Submission from The Owners Corporation 30 – 32 Bardo Road, Newport regarding the following notice of proposed Development:

Application No: DA2020/0502

Address: Lot 33 Sec 2 & Lot 34 Sec 2 DP 4689 34 & 36 Bardo Road Newport

Description: Demolition works and construction of Seniors Housing

Figure 1 – proposed site plan

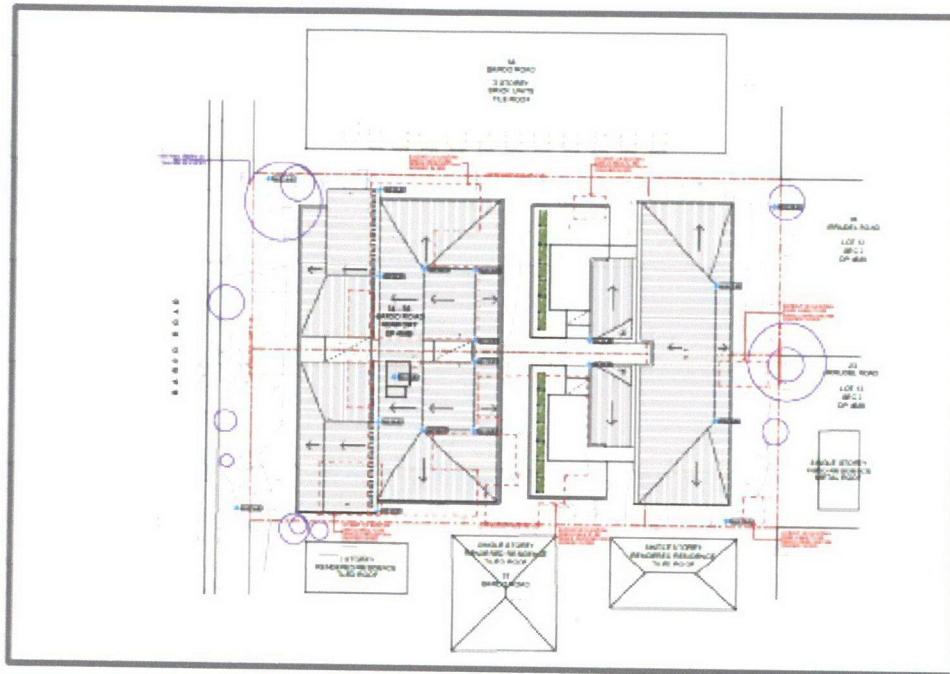
As depicted in figure 1 below, the proposed development shall be located to the west of your site. This position is of potential relevance to the stand-alone buildings and portion of main building at the rear of your site, all along the western allotment boundary.

Figure 3 – proposed side boundary setback

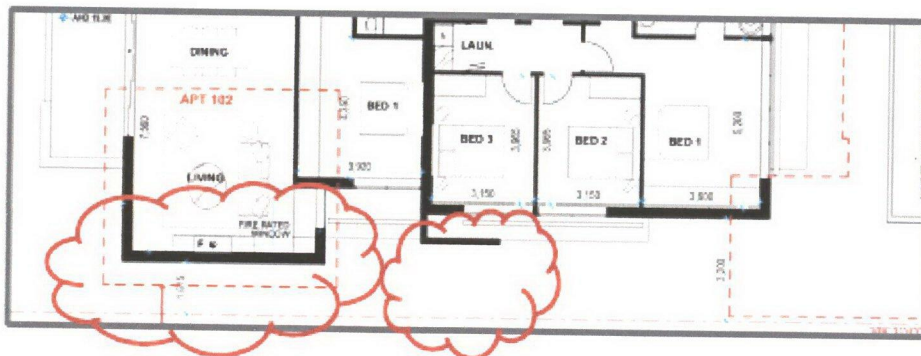
In terms of the shared (western) allotment boundary, the proposed development shall encroach within this limitation as follows –

- Apartment 102 – level 01 shall extend to approximately 1615-mm from the shared allotment boundary
- Apartment 104 – ground / level 01 shall contain an external wall that shall extend to approximately 2000-mm from the shared allotment boundary

These encroachments are depicted in figure 3 below.

Figure 4 – shadow diagram

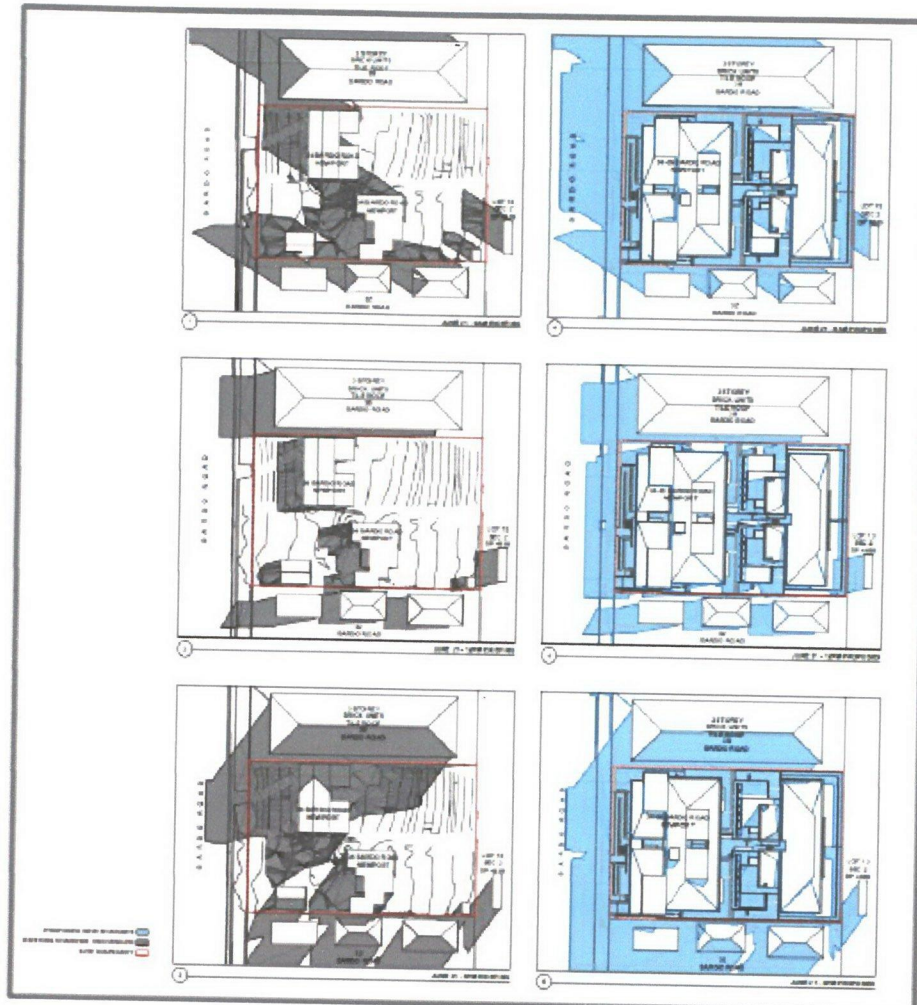
The architectural plan set included within the Development Application submission includes a shadow diagram identifying the probable impact of overshadowing from the proposed development.

A copy of this shadow diagram is included in figure 4 below.

This shadowing is taken at the times of 9:00am; midday; and 3:00pm.

In terms of impact on the property 30-32 Bardo Road, this shadow diagram indicates that –

- At 9:00am, there is no overshadowing of your site
- At midday, the proposed development has only a very minor additional shadowing impact from that which is currently experienced from the buildings / structures on the adjoining allotment; and
- At 3:00pm, the proposed development shall have a more substantive impact (when compared to that which is currently experienced from the buildings / structures on the adjoining allotment).

NOTE: The shadow diagram provided does not accurately depict the rear building on your allotment.

Figure 5 – 3:00pm shadow diagram

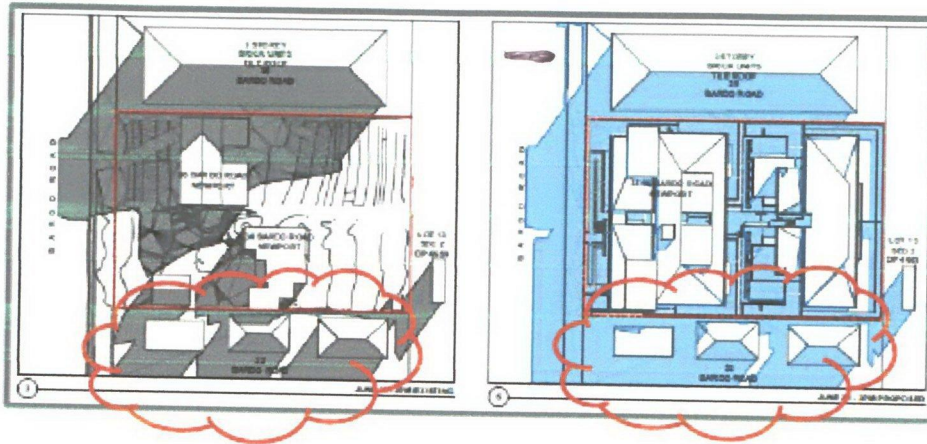
In figure 5 below, the 3:00pm element of the figure 4 diagram is expanded for easier viewing.

- Visual amenity due to the encroachment of the development within 3-metres of the shared allotment boundary; and
- Reduced solar access at the 3:00pm time.
